AGENDA

Architectural Review Board

August 22, 2017

820 East Fairview Avenue

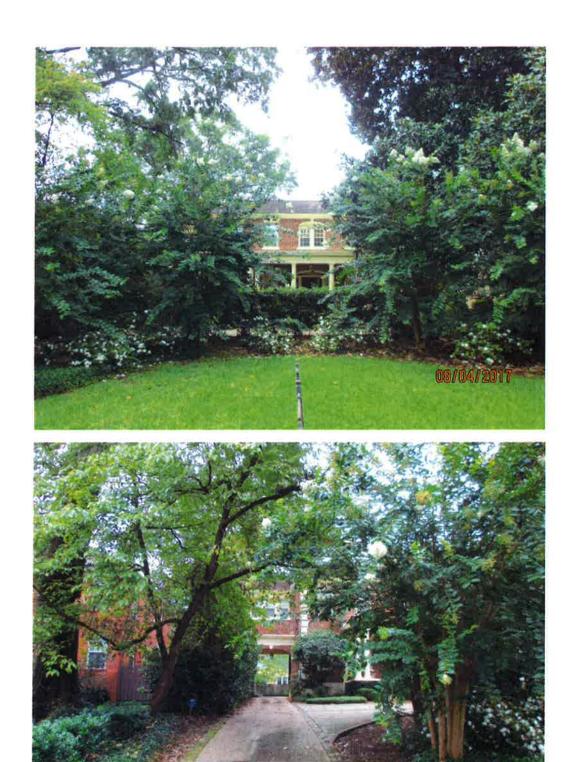
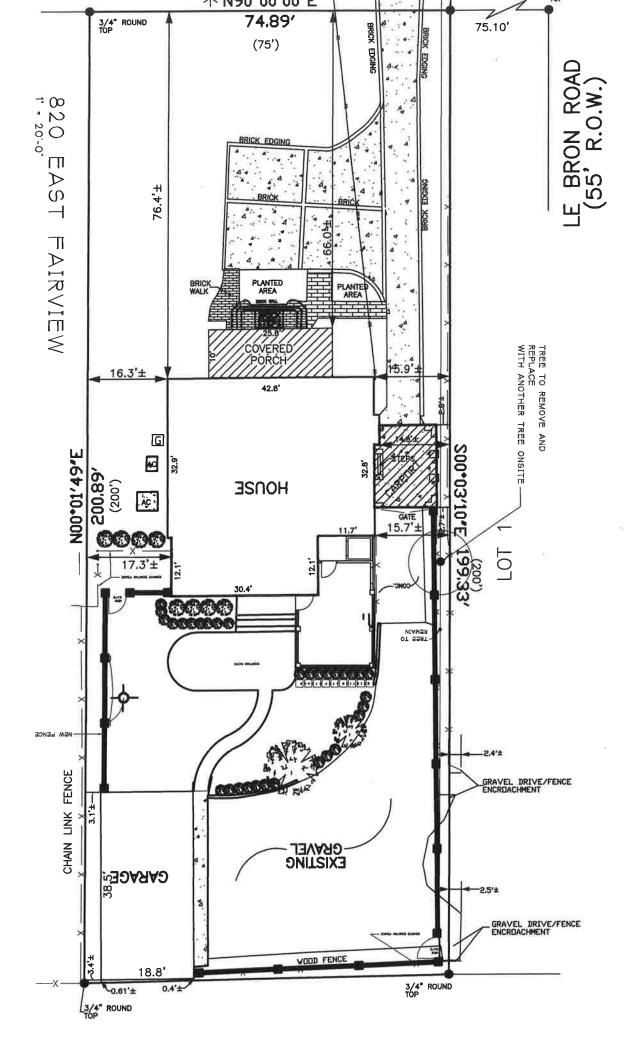
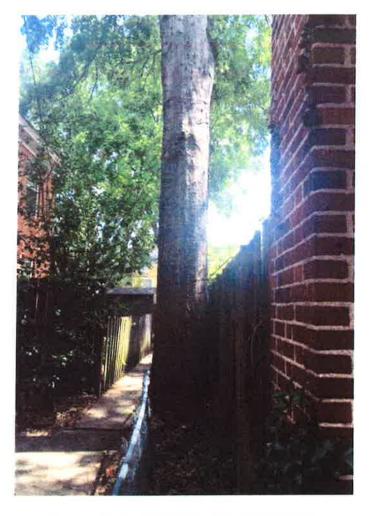
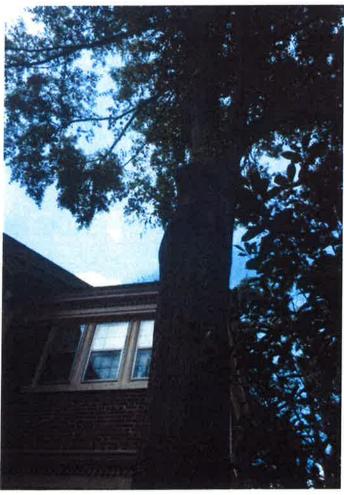
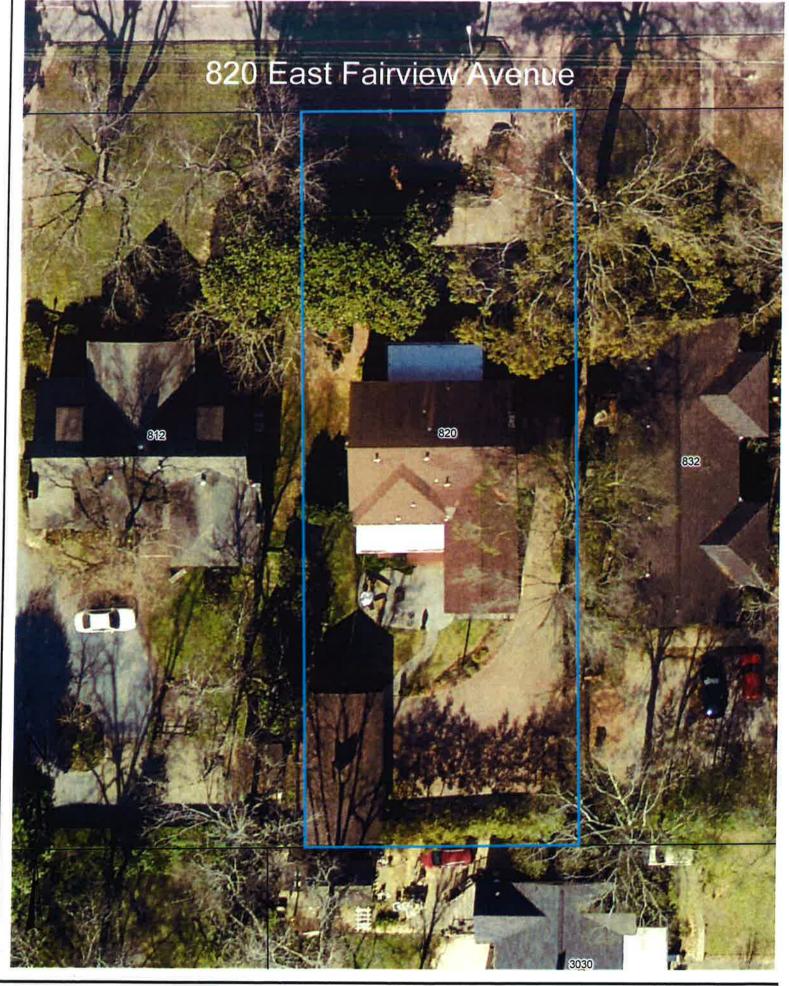
REMARKS: The petitioner is requesting permission to remove an existing wood fence and replace it with a 7' brick wall with 2 iron gates. Brick will match the house and be laid in the same bond as the house. The wall to be installed in sections as illustrated on the site plan.

To execute the project, the petitioner is also requesting permission to remove a 32" water oak tree in the fence line. A dogwood, maple, or tree recommended by the Urban Forester is proposed for the front yard, to be planted in the fall, 2017.

• The Urban Forester recommends a species of oak for the replacement.

1612 Madison Avenue

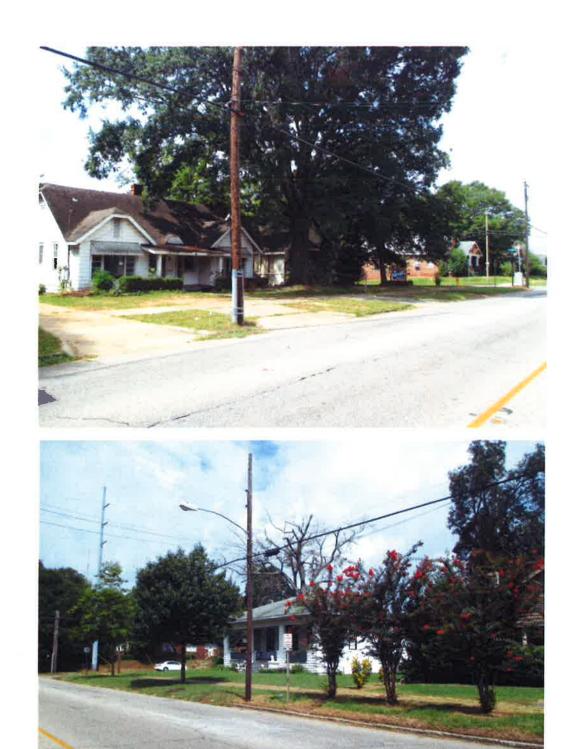
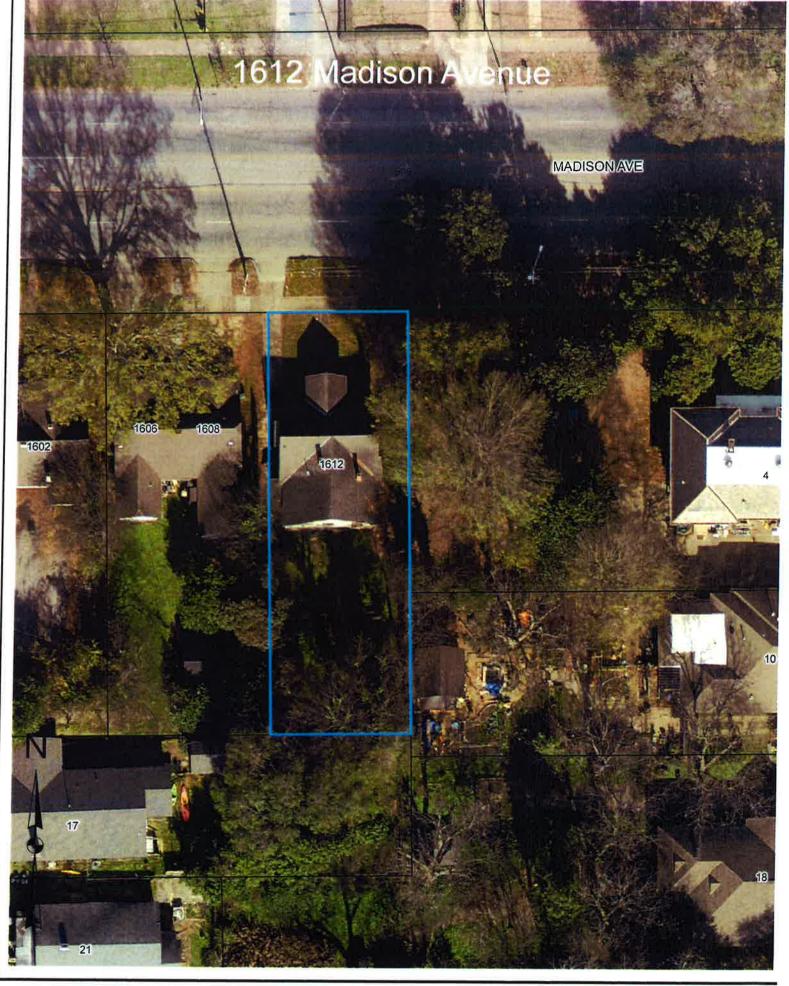
REMARKS: The petitioner is requesting permission to retain installed 4/4 Enviroguard cellular PVC windows. The original window configuration was 6/6 wood.

- 4/4 windows are not common in Capitol Heights, 4/1 are more common.
- A building permit was issued for interior repairs.
- The Board is reminded that just because the windows are installed does not mean they have to be approved. The Board is charged with determining if the 4/4 window negatively impacts the historic materials or appearance of the property and/or district.
- If the Board reaches a compromise solution, a deadline needs to be set for compliance, to be less than 1 year, should a Municipal Court action be required.
- If the Board denies the petition, it needs to provide a reason, and the violation will be filed in Municipal Court.
